Multistrada 1200 Pikes Peak Preload Adjustment Tube Heat Shield

Model: Multistrada 1200 Pikes Peak Model Year 2016-2017
Technical Service Bulletin SRV-TSB-18-003

Date: Wednesday, Jan 24th, 2018
To: Dealer Principal, General Manager, Service Manager, North American Dealer Network
From: Richard Kenton, Technical Director; Jonathan LaForte, Technical Manager

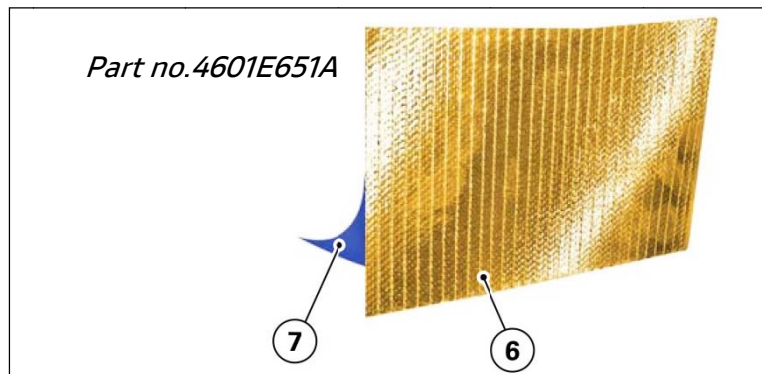
- 6) Take the 'self-adhesive heat shield' (6) and remove the protective film (7) from the back.

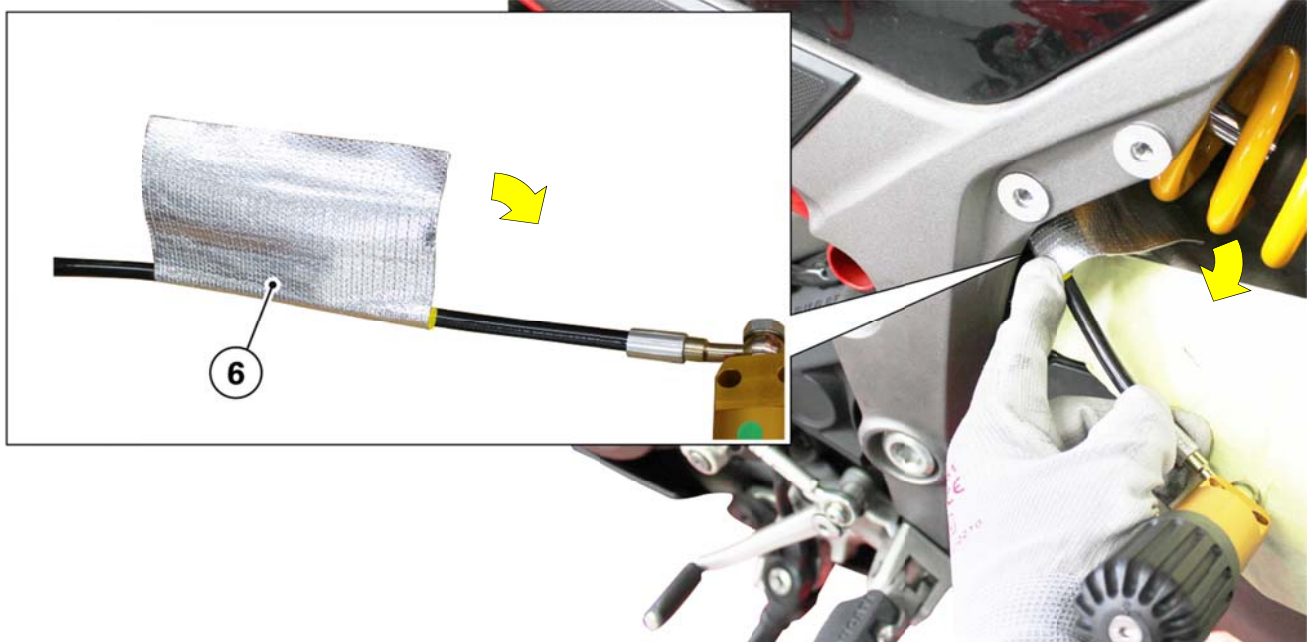
- 7) Starting from the mark made with the marker, wrap the longer side of the 'self-adhesive heat shield' (6) around the pre-load adjustment pipe, as shown in the figure.

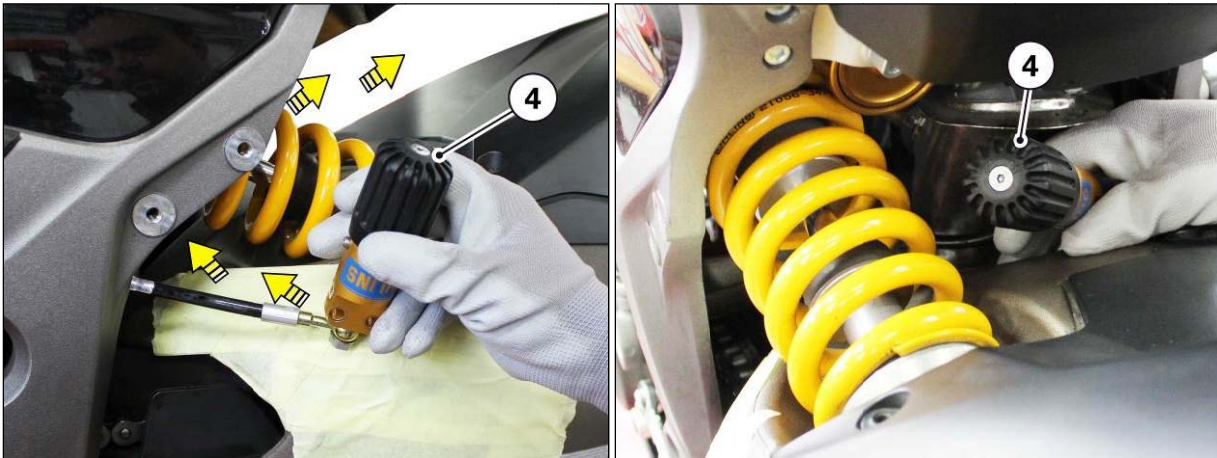
8) Lock the 'self-adhesive heat shield' using **3 small self-locking ties (7)** positioned as shown in the figure.

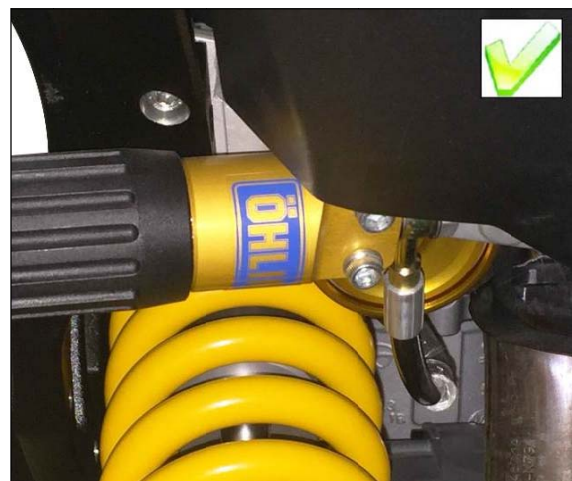
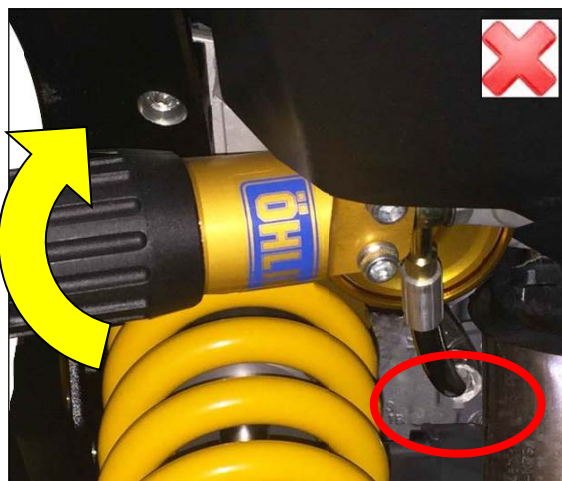
- 10) Position the pre-load adjustment knob (4) on the plate in the orientation shown in the figure, and secure it tightening the 2 M6x25 screws (3) to a torque of 10 Nm ± 10%.
- 11) Position ties (7) with the head facing the spring, as shown in the figure.

Position the pre-load adjustment knob so that the pipe does not come into contact with:

- the rear shock absorber spring

- the vertical head manifold heat guard.
